Demolition of existing structures and the construction of a mixed use building accommodating a Proton Therapy Unit, ground floor commercial tenancy, 12 levels of health and medical research, a plant level, associated car parking and infrastructure

North Terrace, Adelaide

020/A035/18

OVERVIEW

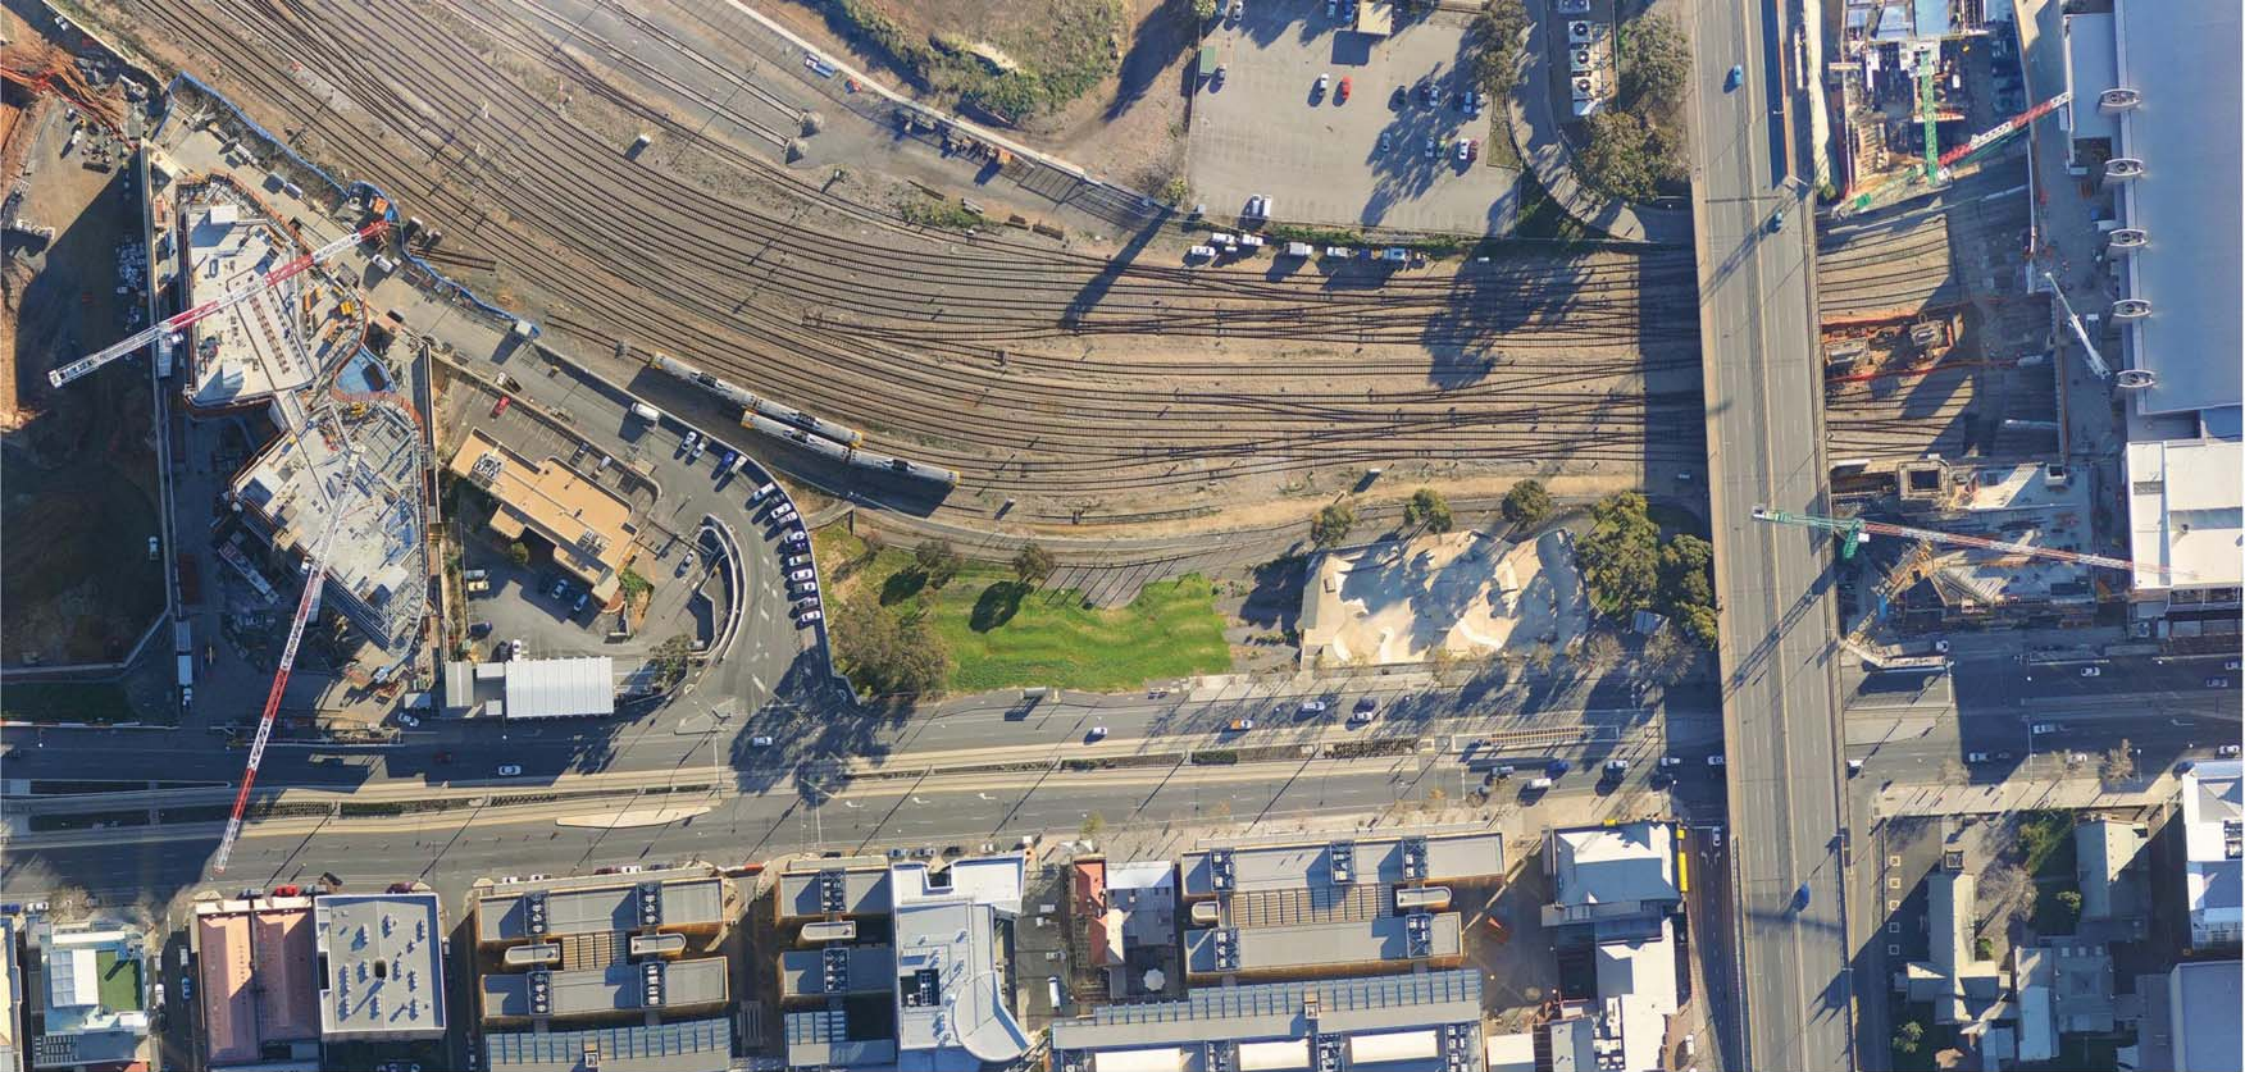
The design statement does not appear to reference the Common Development Framework entered into by UoA, UniSA, SAHMRI and Renewal SA. It talks about links to the Precinct rather than this development being an integral element within a precinct. Overall the "Proposed Application" appears to look at the precinct as SAHMRI and SAHMRI 2 rather than the broader Biomed precinct.

The ground plane does not appear to address the principals of the Common Development Framework and directs pedestrians to use the main North Terrace Boulevard. The Common Development Framework looked to develop links to the North of the precinct for pedestrians and cyclists along the Northern walk which connected to the Morphett Street Bridge.
